Service Bulletin No. 49

Model: TA-4650, -5650

Subject: V-FET Replacement

hi-fi Service Bulletin No. 62

SCHEMATIC DIAGRAM - Power Amplifier Section -
- USA (new type), E, AEP model -

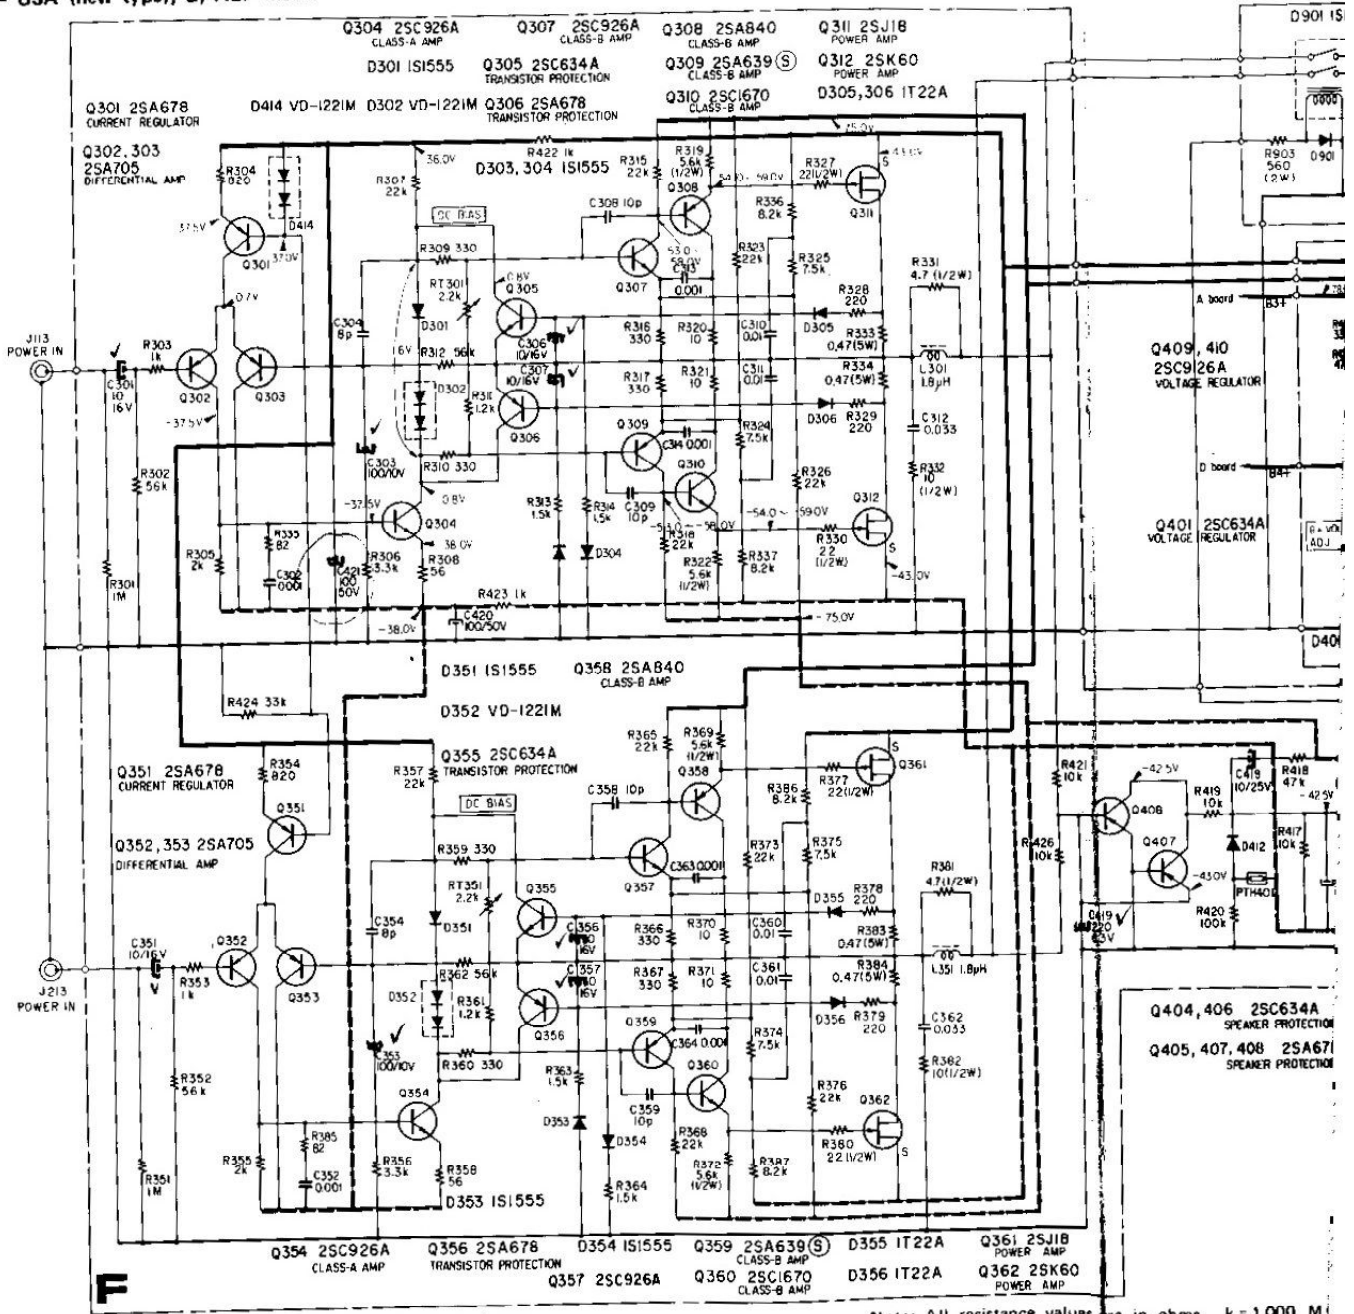
4. Set the dc bias adjust resistor (see below) on the Power Amp Board for maximum reading.

TA-4650, -5650	-	RT-301 (RT-351)
TA-8650, TAN-8550	-	RT-701 (RT-751)
TAN-5550	-	RT-501 (RT-601)

5. Turn off the power and install the replacement V-FET. Reapply power and reset the dc bias according to the service manual for the respective model.
